Design as modified by Kit 36-4007 (Required by Mandatory Service Bulletin No. 2457)

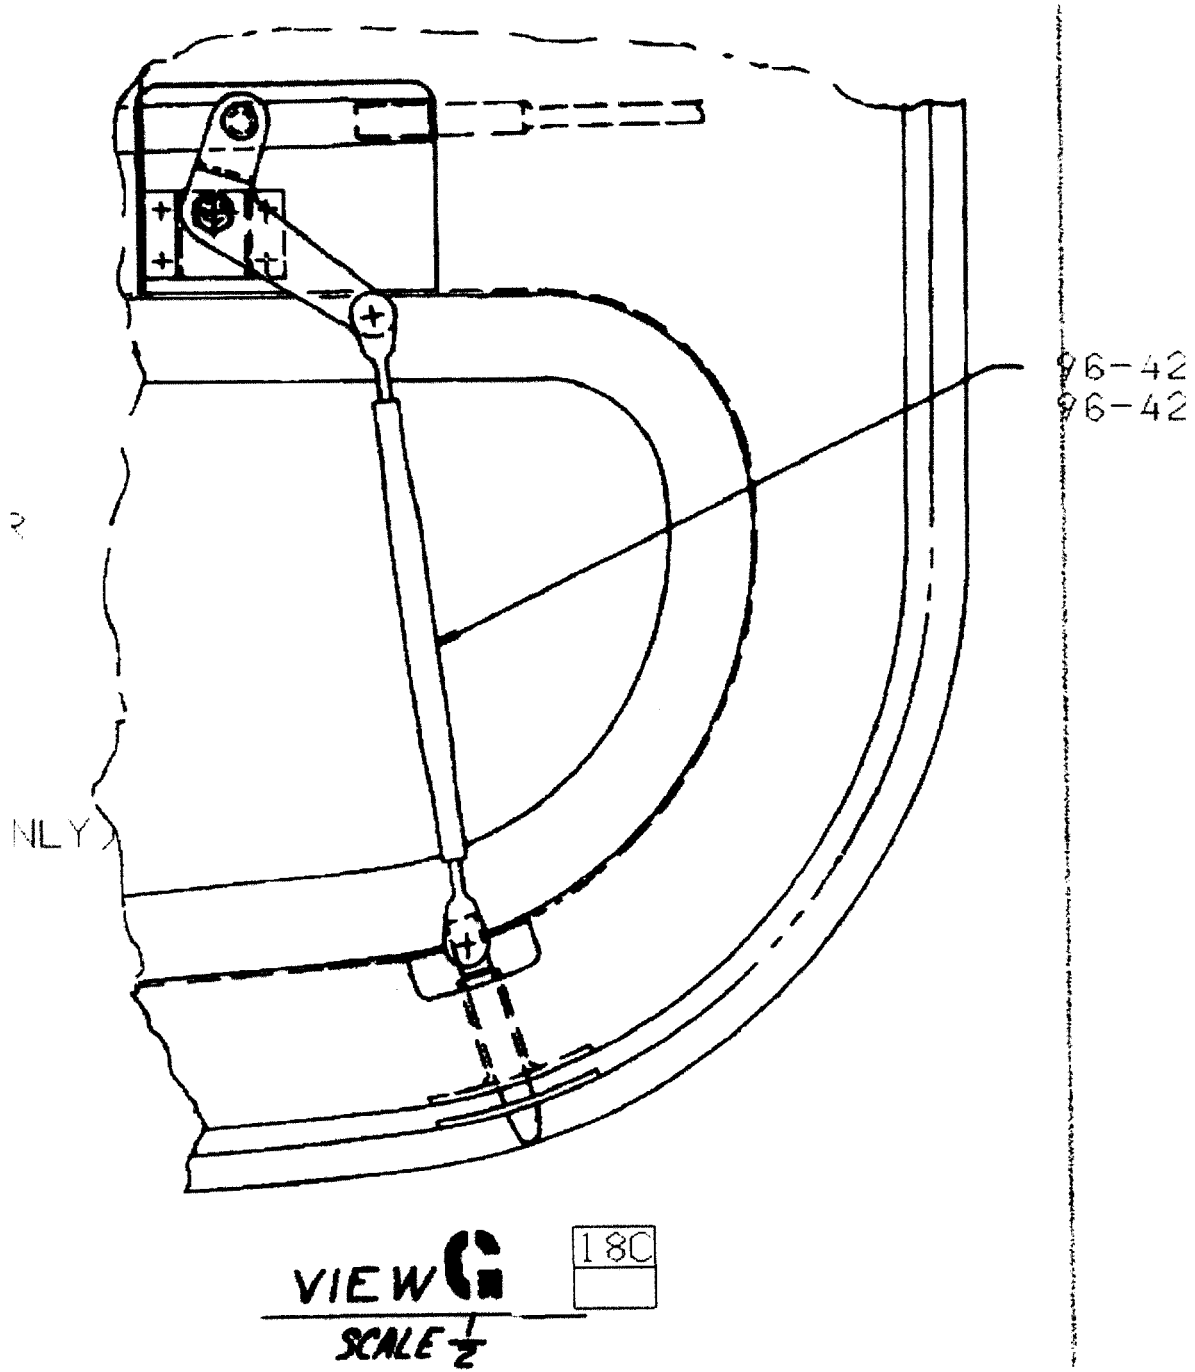
Original Design (Accident Condition)
